**Subject: Revision of Class 1 Permit Modification Notification for Adding a Support Structure to Pad 11 for the Los Alamos National Laboratory Hazardous Waste Facility Permit, EPA ID No. NM0890010515**

Revised Class 1 Permit Modification Notification for Adding a  
Support Structure to Pad 11 for the Los Alamos National Laboratory  
Hazardous Waste Facility Permit, EPA ID No. NM0890010515

**Revised Class 1 Permit Modification Notification for Adding a Support Structure to Pad 11 for the Los Alamos National Laboratory Hazardous Waste Facility Permit, EPA ID No. NM0890010515**

**Figure G.12-1:** Technical Area 54, Area G, Pad 11 Outdoor Container Storage Unit Grid Sampling and Additional Sampling Locations

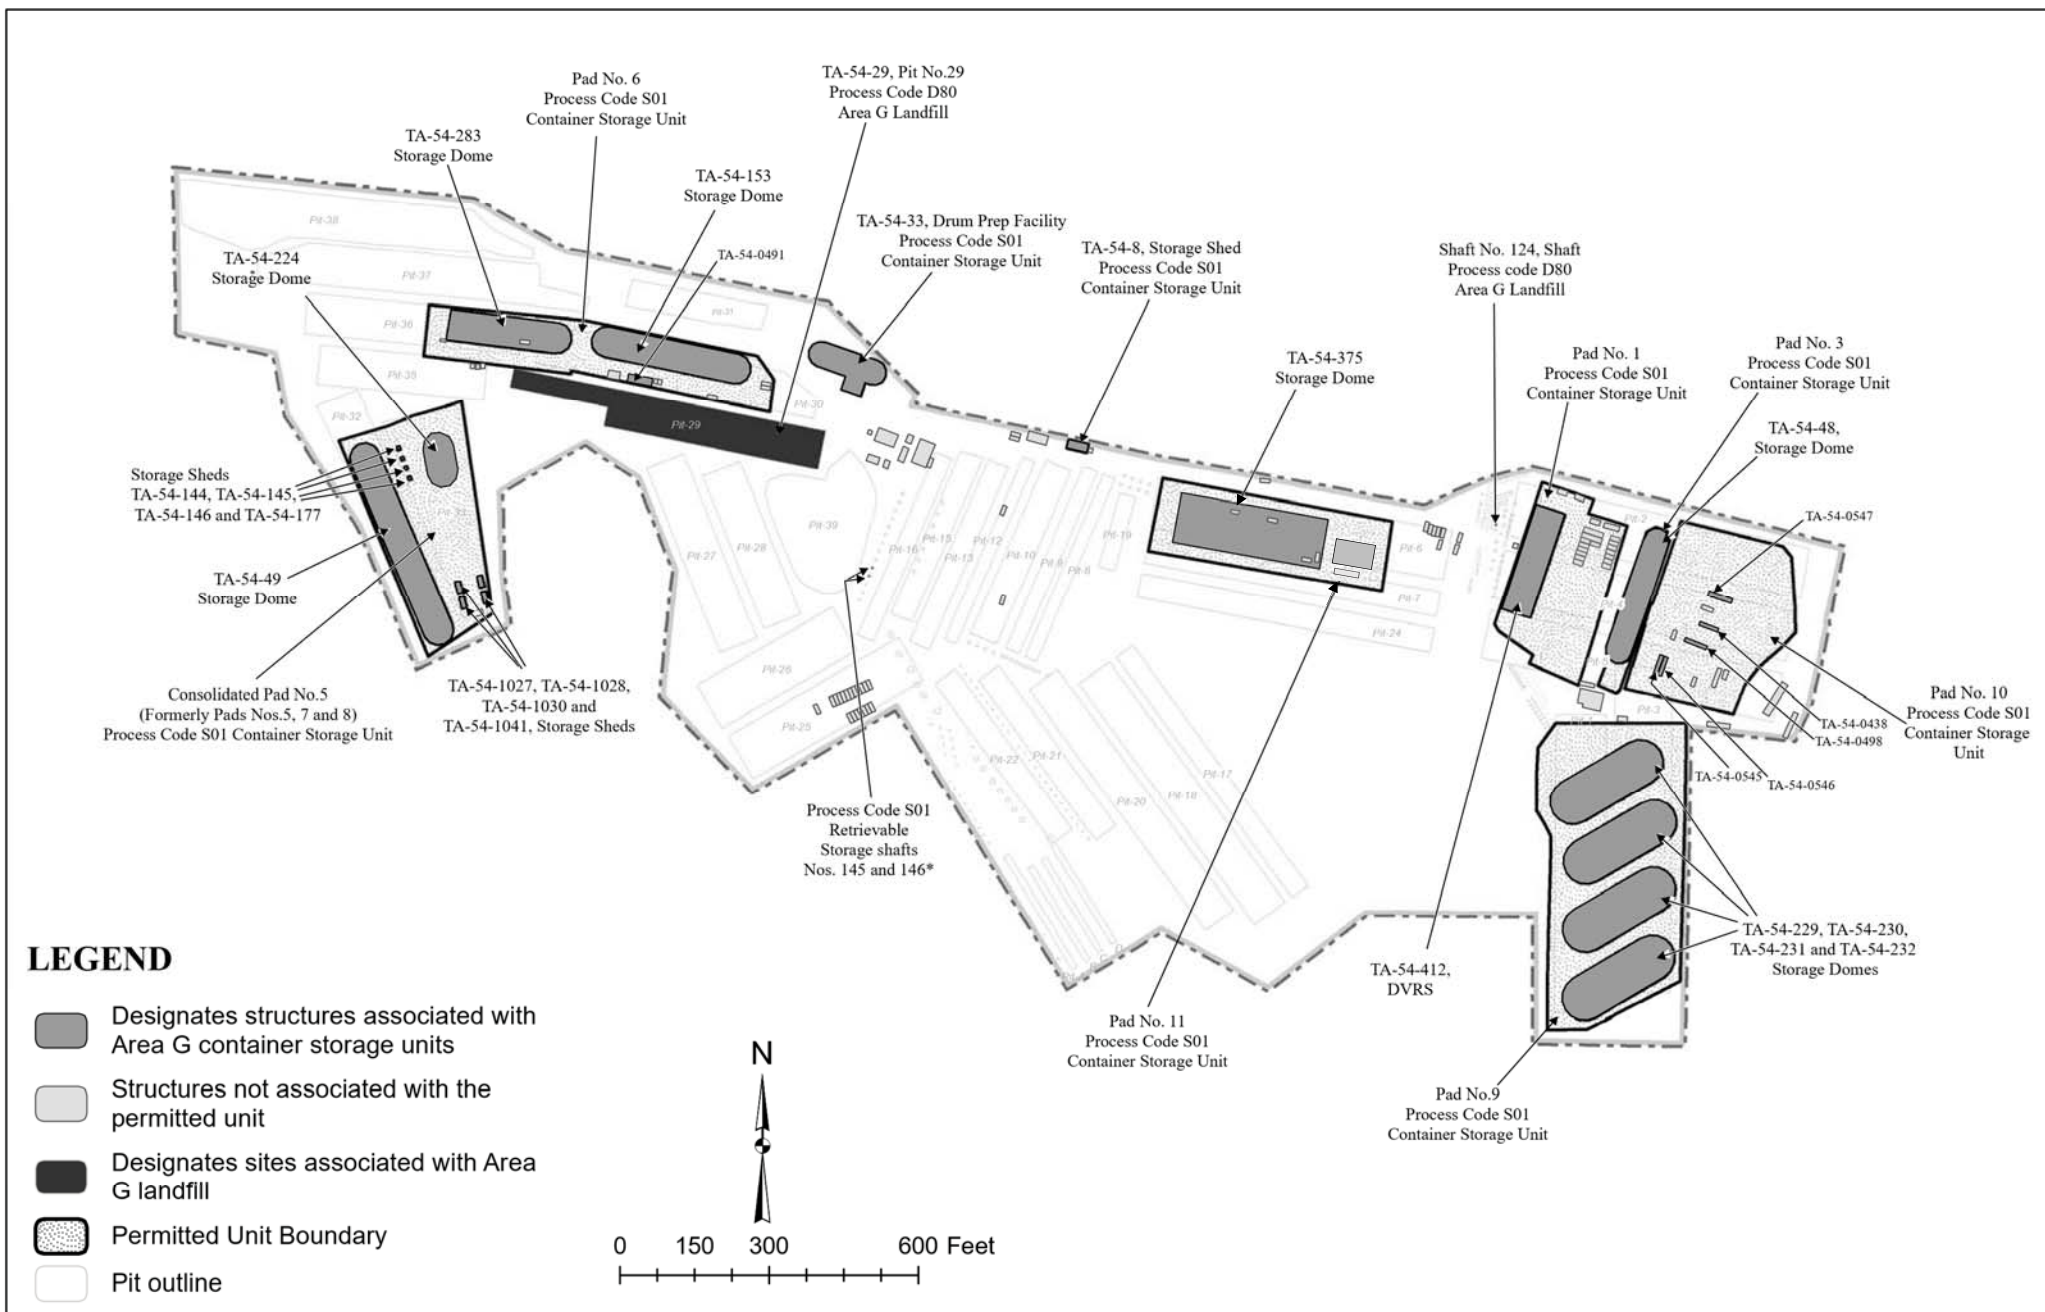
Attachment 1 contains the changes to the Permit Attachments A and G. Attachment 2 contains revised Figures 27 and 36 from Attachment N of the Permit and revised Figure G.12-1 from Attachment G of the Permit. Attachment 3 is the certification statement signed by DOE and N3B for this permit modification request as required by 20.4.1.900 NMAC, incorporating 40 CFR 270.42.

Descriptions of the trailer have been added to Section A.4.2.9 in Attachment A, "Technical Area (TA) - Unit Descriptions," and Section 2.0 in Attachment G.12, "Technical Area 54, Area G, Pad 11 Outdoor Container Storage Unit Closure Plan." Figures 27 and 36 in Attachment N, "Figures," have been revised; and Figure G.12.1 in Attachment G.12 has been revised.
